SB Number:	SB 2FZ-036	Creation Date: 05/11/2008
Subject:	<i>"Parts fuser drive assy" parts have been changed, to make them compatible with other machines</i>	
Model:	KM-C2520/3225/3232/2525E/3232E/4035E

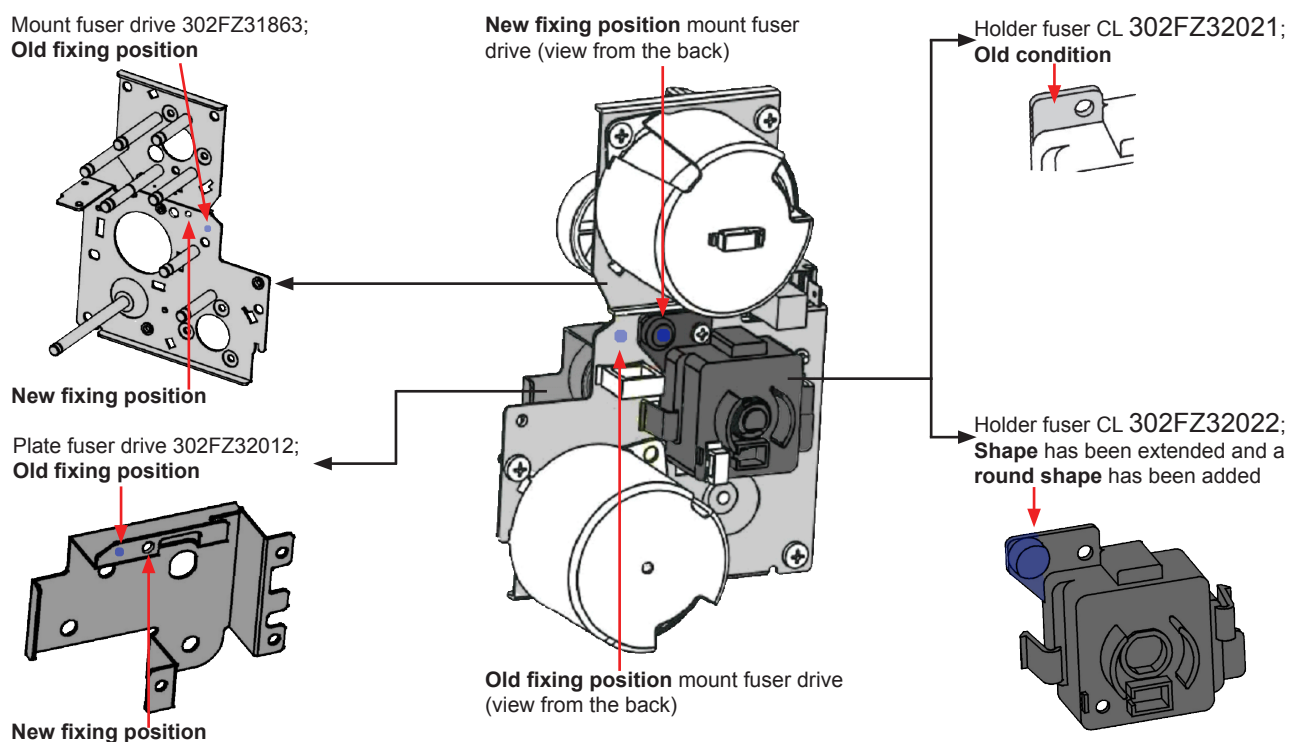
Contents of changes	<p>To ensure compatibility with other machines, the mount fuser drive, plate fuser drive and holder fuser CL have been changed as follows:</p> <ol style="list-style-type: none"> 1. The fix positions of the mount fuser drive and the plate fuser drive have been changed. 2. The shape of the holder fuser CL has been changed.
----------------------------	--

Classification	<input type="checkbox"/> Entire stock rework	<input type="checkbox"/> In-field modification at next visit	<input type="checkbox"/> In-field modification by case	<input checked="" type="checkbox"/> No modification necessary
Field measure	Make sure that only a combination of old parts or new parts is possible, when replacing the parts.
